Interactive comment on “Small farm dams: impact on river flows and sustainability in a context of climate change” by F. Habets et al.

Received and published: 3 April 2014

Interactive comment on *Hydrol. Earth Syst. Sci. Discuss.*, 10, 14391, 2013.

Fig. 1. Histogram of the mean depth of 171 small farm dams in southwestern France

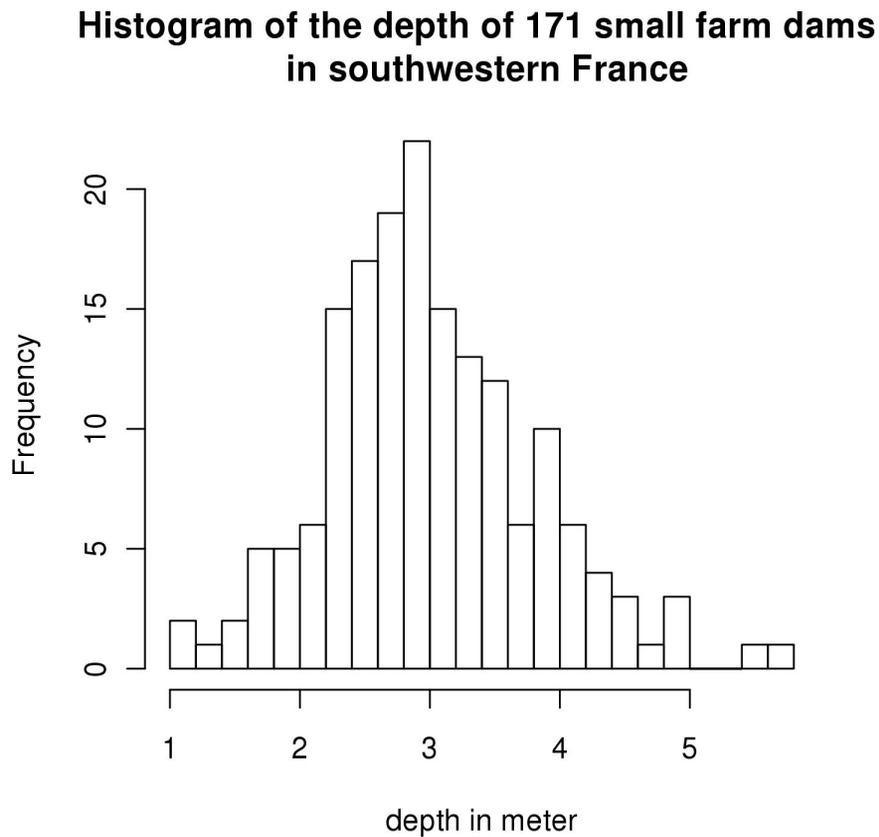
7) Also regarding pond size, and as noted in the discussion, power law relationships are usually utilized for area-volume relationships of such tanks. Although the authors indicate awareness of such relationships, it is not clear why they used the simpler geometric relationship for estimating tan

We did not used a area-volume relationships, because it was not clear if the relationships used in South Africa, America or Australia could apply in France. Indeed, the regulation in France is not the same for the dams that are deeper than 5 m, and most of the small farm dams have a depth smaller than 5m. The data collected on 171 small farm dams in south western France lead to an average depth of 3m, as shown in the figure below. For these reasons, we used a linear relationship.

- section 2: " An average value of $d_w = 3$ m was chosen, as it is the average depth of a short database referencing 171 small farm dams in south-western France, and as it is below the 5 m for which an annual survey of the dam structure is required."
- discussion: " However, the depth of 3 m was used as it corresponds to the aver-
